Comments and suggestions on Masterplan 2023 With required revisions to Policies TC1-4 as Required.

By Dorian Kelly

DRAWING A: Concrete amphitheatre, Firstsite shown behind.

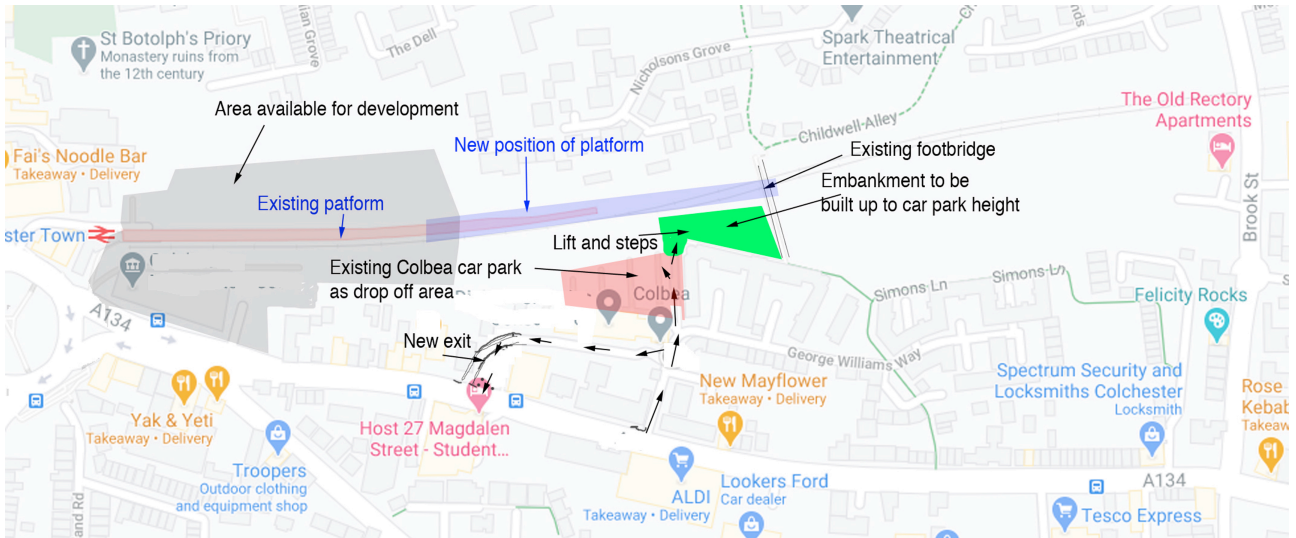
- *Drawing C* below shows in sketch form such a development, the north end of which is an all-weather cast concrete open access amphitheatre (see *Drawing A*), usable for music and theatre. At the south end of the building there is a glass conservatory/café with artworks, planting, good lighting and is open till late. The drawing also shows seating planters. This will keep the area busy and animated.

At the rear of the D-Shaped stage (not a raised stage) is a part of a terrace of building on two levels which are artists studios with living accommodation. The North end of this building is devoted to dressing room and storage, and has a patio style window access to a small balcony, and at ground level, two doors to a plain room beyond. The South end is a glass conservatory and café.

Light pillars are not as shown but brought in as required in the form of vertical 300 x 300 truss, floor anchor and power will be required.
